NEW MEXICO ENERGY, MINERALS  
& NATURAL RESOURCES DEPARTMENT

*Re: Administrative application for waterflood expansion pursuant to Division General Rules 701.G(6) and 701.C for the Lusk West (Delaware) Unit Waterflood Project in Sections 20, 21, and 29, Township 19 South, Range 32 East, NMPM, designated and Undesignated West Lusk-Delaware Pool, Lusk West (Delaware) Unit, Lea County, New Mexico.*

CASE NO. 11704  
ORDER NO. R-10863

### **SUMMARY OF WELLS TO BE REVIEWED IN ACCORDANCE WITH ORDER NO. R-10863**

3 1980' FSL & 1980' FWL SEC-29 T-19-S R-32-E  
WELL NO. FOOTAGE LOCATION SECTION TOWNSHIP RANGE

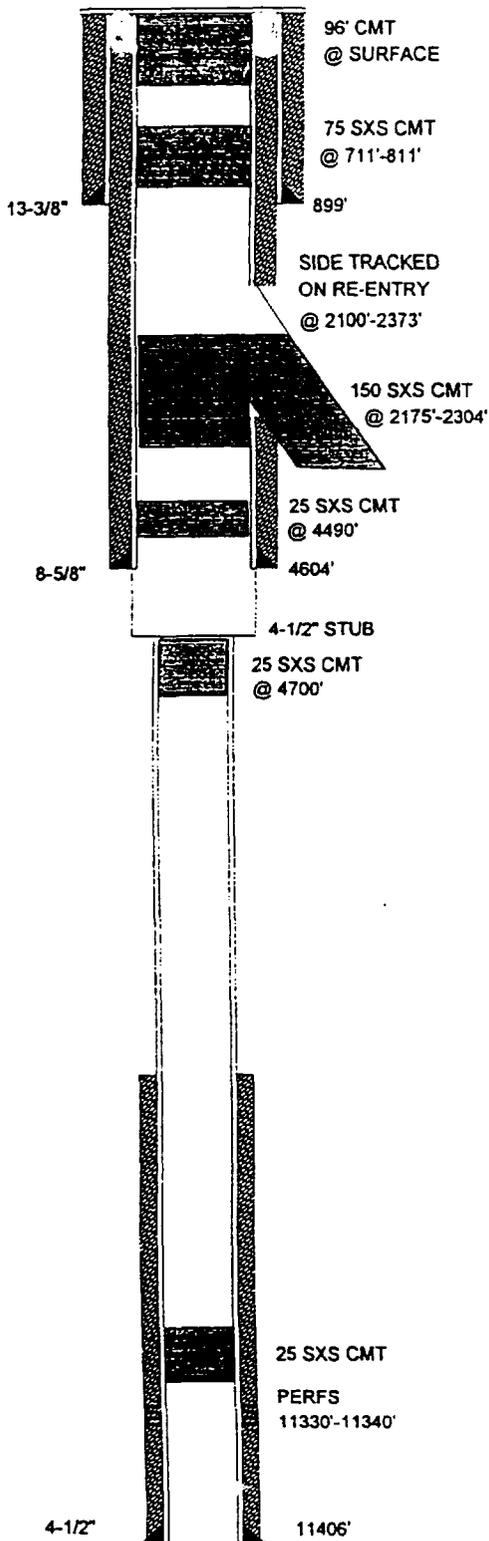
**Well Name:** S. A. Bowman Federal #3  
Current Status: Plugged and Abandoned  
Open Interval: 4700' - 8960'  
Waterflood Interval: 6421' - 6439'  
Porosity: 16% to 18%  
Thickness: 18 Feet  
Zone Quality: Very Good

**Upon this review, Mr. Williams concluded that no additional work was required by PNR concerning these eight wells in order to prevent the migration of fluid from the proposed injection zone to the eight wellbores in question.**
